Stressed receiver sensitivity setup and calibration (comments R1-304 R2-196, R2-203)

Piers Dawe and Jakob Toft
NVIDIA

Figure 121–8—Stressed receiver conformance test block diagram

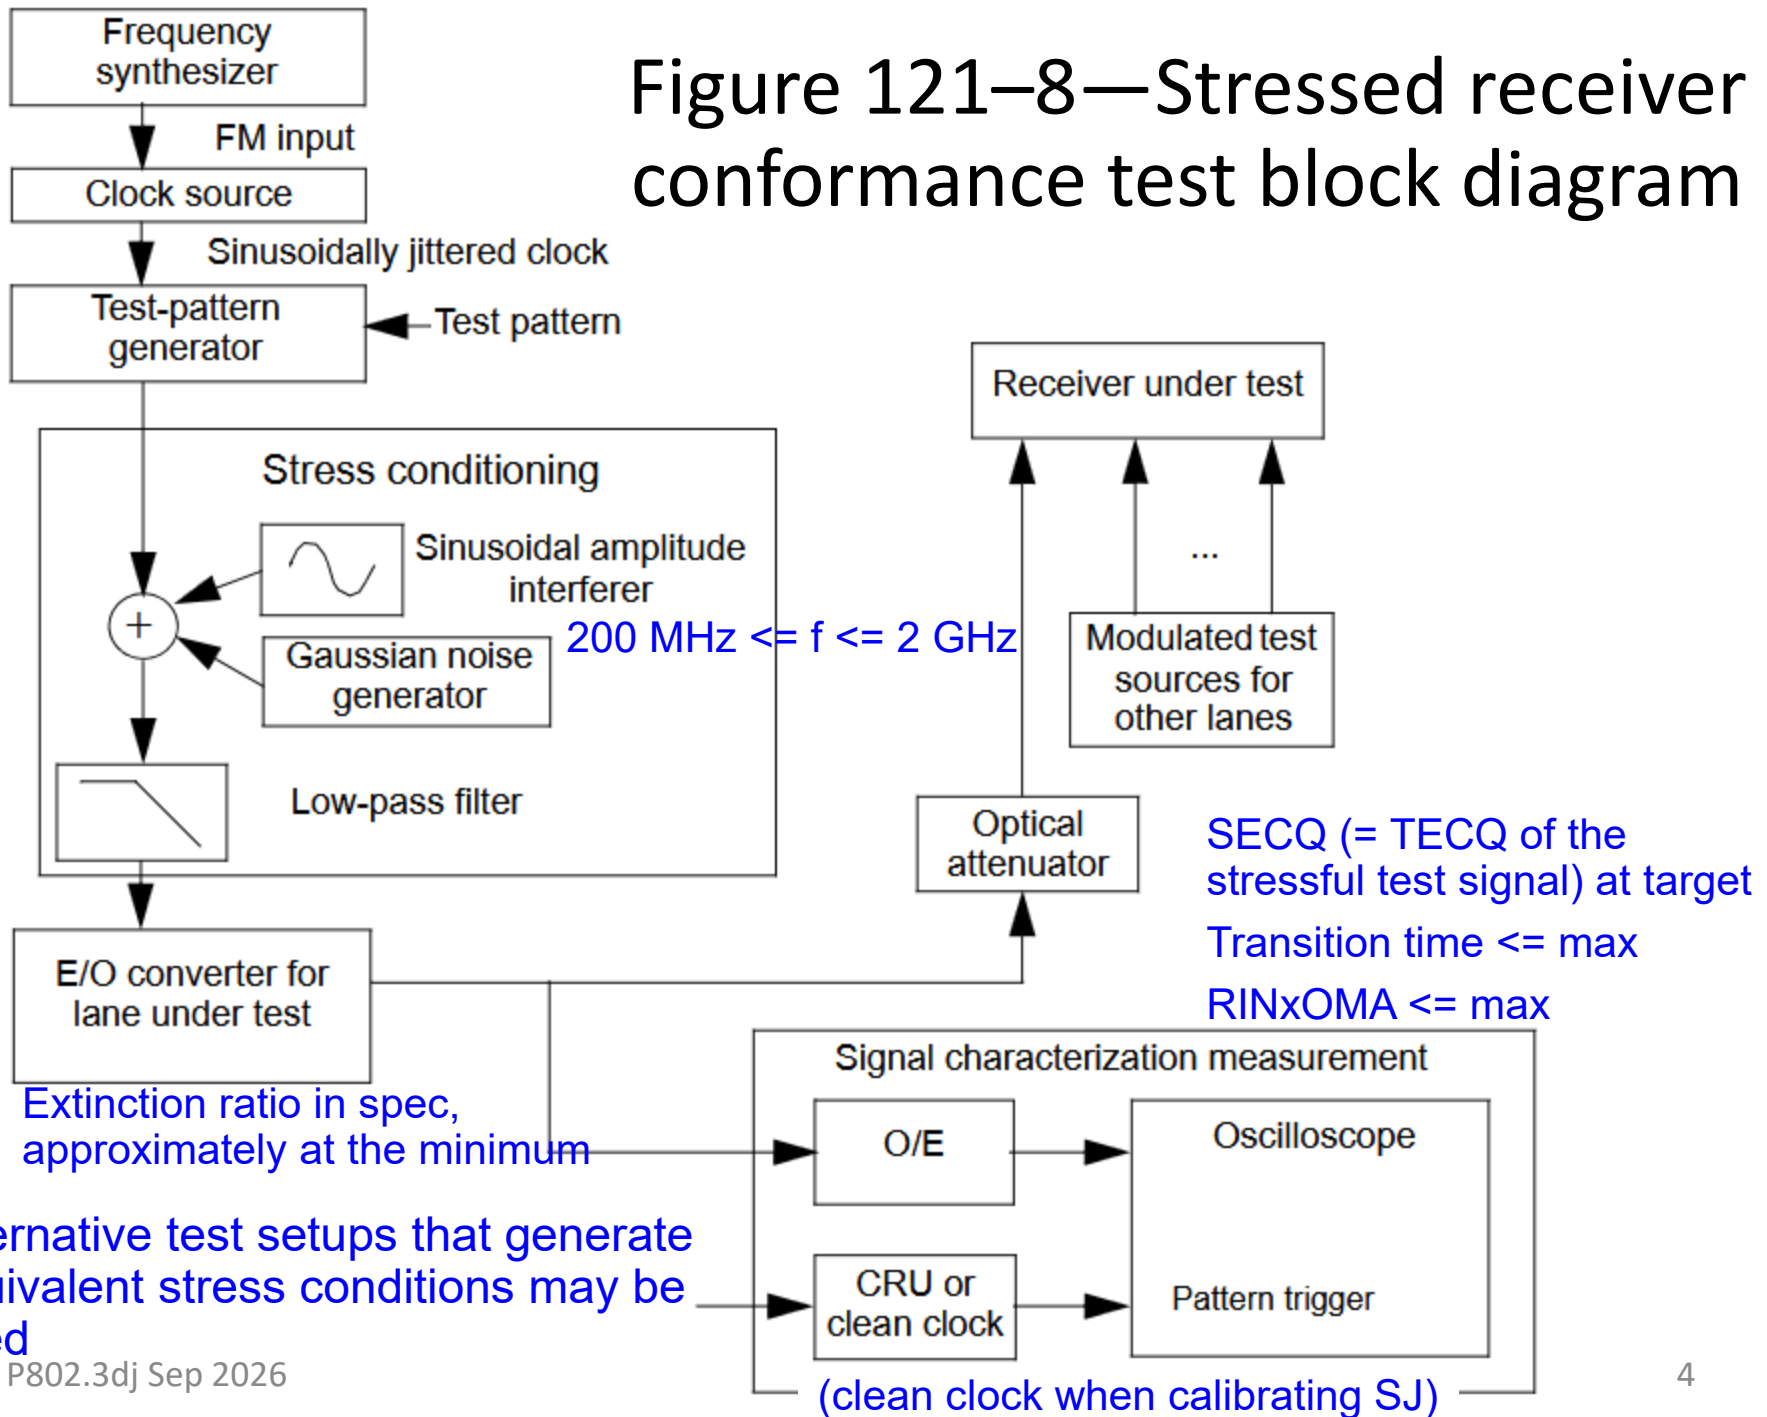
- R1-304 SC 180.9.15 P 493 L 45 TR
 - The frequency of the sinusoidal interferer was changed from minimum 100 MHz to minimum 200 MHz, but it's still **a single frequency. The sampling scope aliases it to some other frequency and the software FFE will amplify it according to the apparent frequency, not the real one, causing error.**

- R2-203 SC 180.9.15 P 510 L 28 TR
- The frequency of the sinusoidal interferer was changed from minimum 100 MHz to minimum 200 MHz, but it's still a **single frequency** (comment R1-304). The minimum* remains at 2 GHz, same as it was at 10 Gb/s. Back then, for PAM2, without equalisers or FEC, that was a range from 4% to 39% of Nyquist; now it's 0.4% to 1.9%. Most unequalisable distortion, and reflections and crosstalk have spectra like the victim or weighted to higher frequencies, not lower. Also a stressed signal with significant sinusoidal interferer can have bimodal levels (which didn't really matter for PAM2 without equaliser). So, both the spectrum and the distribution are **unrealistic** and **not suitable** to subject real receivers to. The sampling scope aliases the real SI frequency to some other frequency which can be much higher than Nyquist and the software FFE will amplify it according to the apparent frequency, not the real one, causing a **calibration error** which can be surprisingly large. A PAM2 interferer has a better spectrum than the sinusoid but the same **bimodal issue**.

- With reference to Figure 121–8: change from sinusoidal interferer to PRBS13Q, summed with the others before the low-pass filter as today
- With a QPRBS interferer, there are many frequencies. They are aliased too, but the noise enhancement of the aliased spectrum and the real spectrum is similar so that's OK

- 1. Change from a sine tone to a PRBS generator (not synchronous to the victim) with a high enough signalling rate that wherever the aliasing takes the apparent frequencies to (there are many real frequencies in a PRBS), the overall enhancement will be reasonably consistent. A PAM2 PRBS is more "bounded-like" than a PAM4 one as well as having a uniform spectrum.

- 2. Limit the amount of bounded interference.
 - 3. In 121.8.10.1, we say "care should be taken to avoid harmonic relationships between the sinusoidal interferer, the sinusoidal jitter, the signaling rate, and the pattern repetition rate". After taking advice from scope experts: add the sampling rate of the scope to that list.
-

- 1. **Change from a sine tone to a QPRBS generator** (not synchronous to the victim) with a signalling rate similar to the victim and passed through the same or similar filtering to the victim.

- 2. Apply a maximum limit to the bounded interference (now QPRBS), or **apply a minimum limit from filtering**, e.g. minimum 1.9 dB from filtering alone.

- 3. In 121.8.10.1, we say "care should be taken to avoid harmonic relationships between the sinusoidal interferer, the sinusoidal jitter, the signaling rate, and the pattern repetition rate". Modify this as necessary for the different interferer and after taking advice from scope experts, **describe how the frequency of the interferer and the sampling rate of the scope should be related**.

Simulated stressful signal for SRS testing: vertical pdfs of 4 levels combined

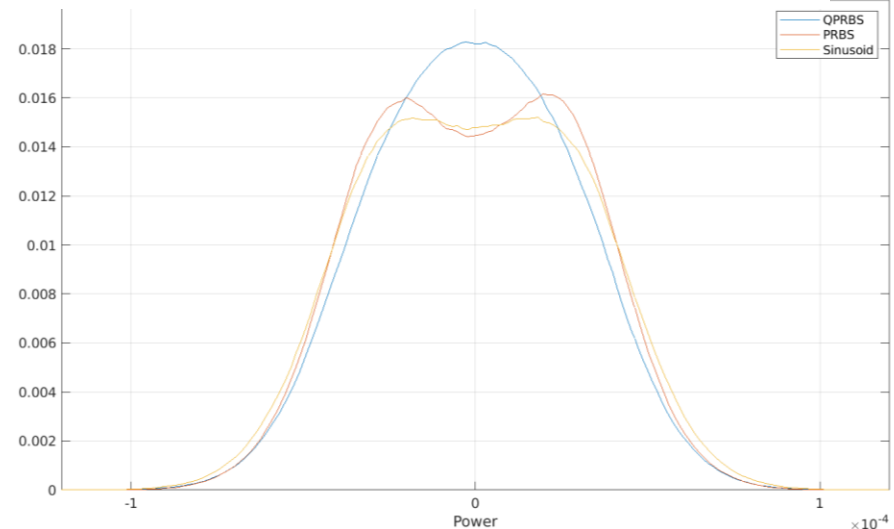
- A sinusoidal interferer is close to "dual-Dirac"
- PAM2 PRBS has the same problem
- Because the interferer is quite strong, the way people build stressed signals today, the resulting PAM4 histograms have two peaks for each level
- This is unrealistic

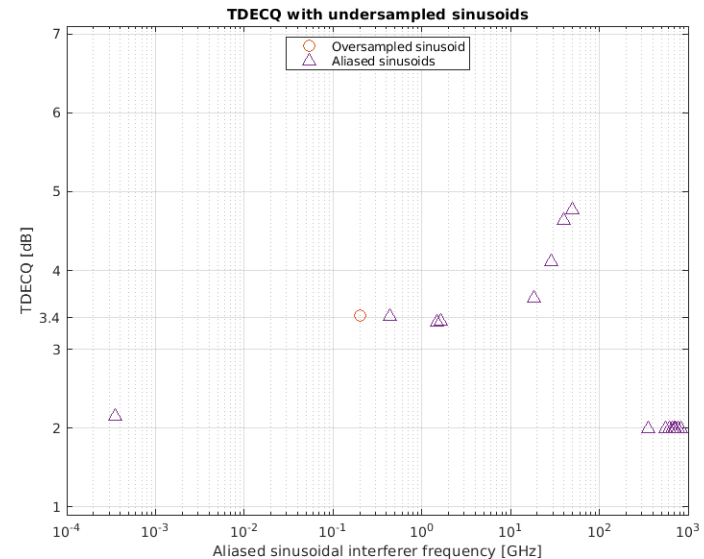
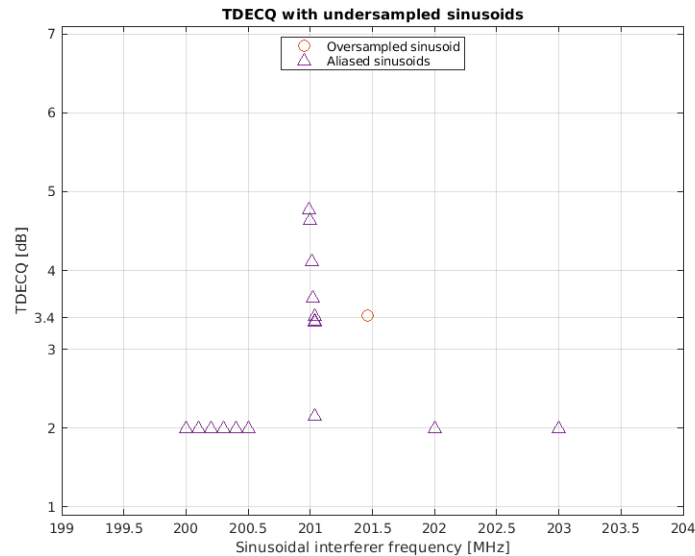
- Examples of aliased SI spectra
 - if the aliasing does not distribute the spectrum – typically a sampling scope acts differently
- A difference of 100 kHz in sinusoidal frequency could move the aliased frequency by 100 GHz
